Amendment, Permit # B16004519

CONSTRUCT PARTITION WALLS IN UPSTAIRS MASTER BATHROOM  
FRAME PERIMETER WALLS TO CREATE LARGER GUEST BATHROOM  
ON 2ND FLOOR

**Lakeside Drive Residence**  
13773 Lakeside Drive  
Clarksville MD 21029

APPROVED  
WALK-THRU BUILDING PERMIT  
BP# B16004579 A#  
APP. SAN Robert Freeman DATE: 11/19/16  
DESC. OF WORK: Construct Partition walls in  
upstairs Master Bathroom from perimeter walls  
to create larger guest bathroom on  
2nd floor.

**1** New Construction: Second Floor Plan  
SCALE: 3/16" = 1'-0"

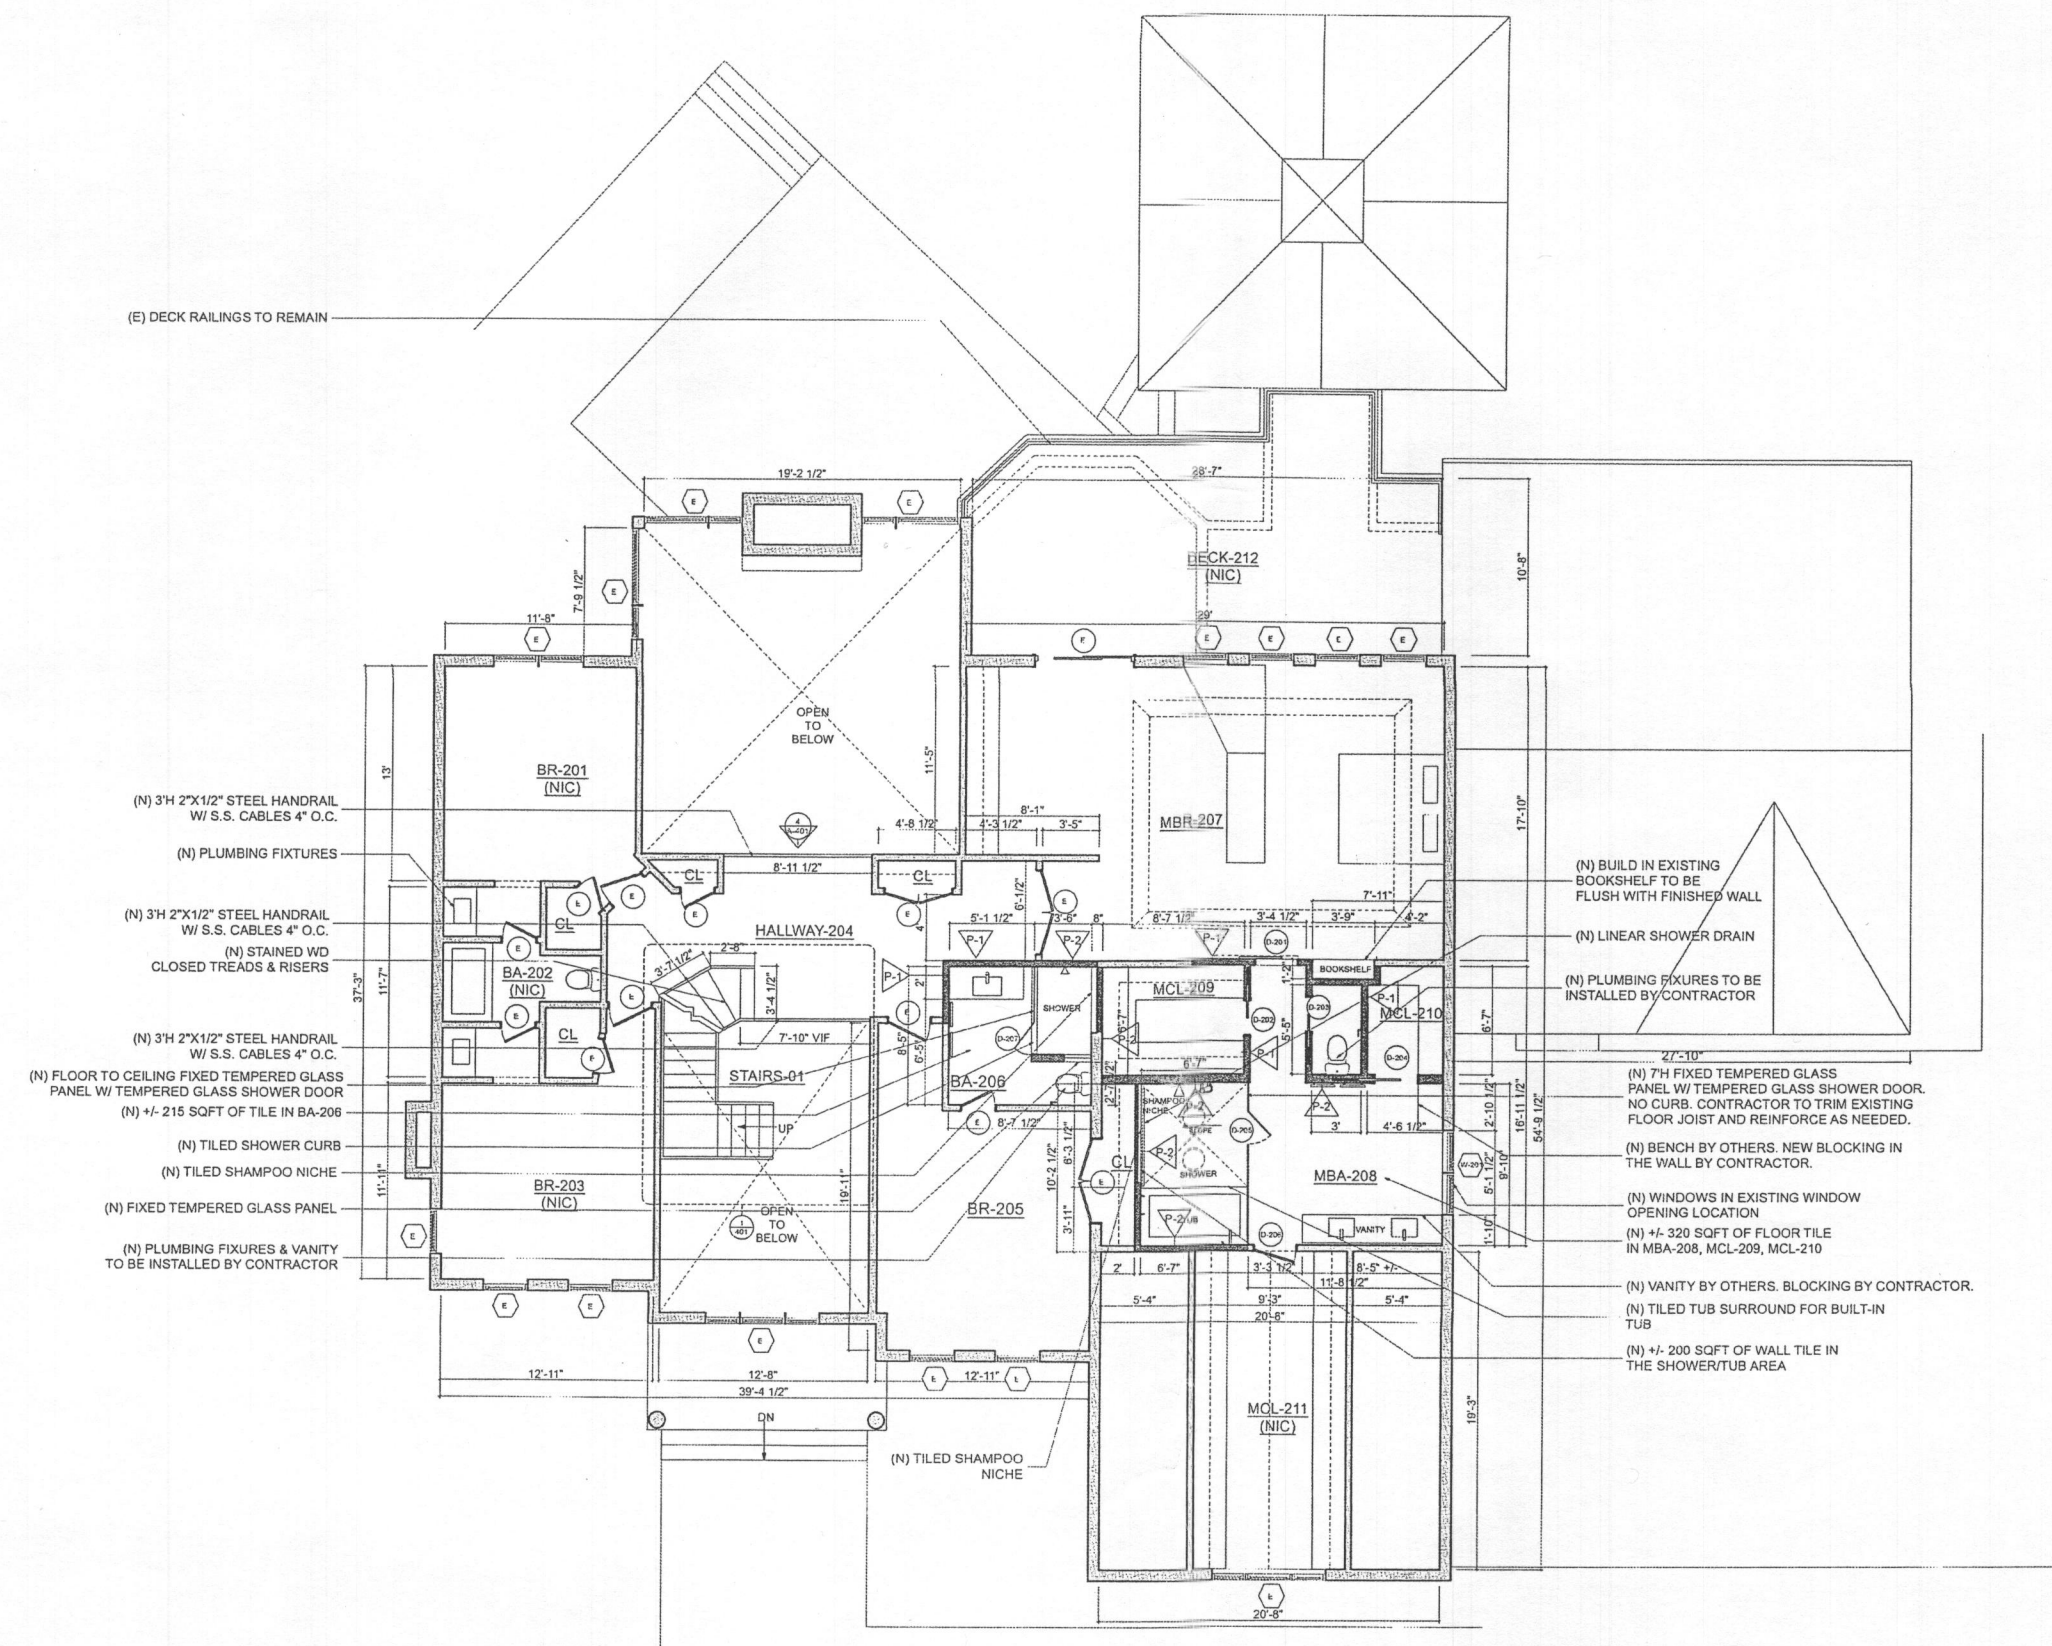
Other: REVISED FLOOR PLANS
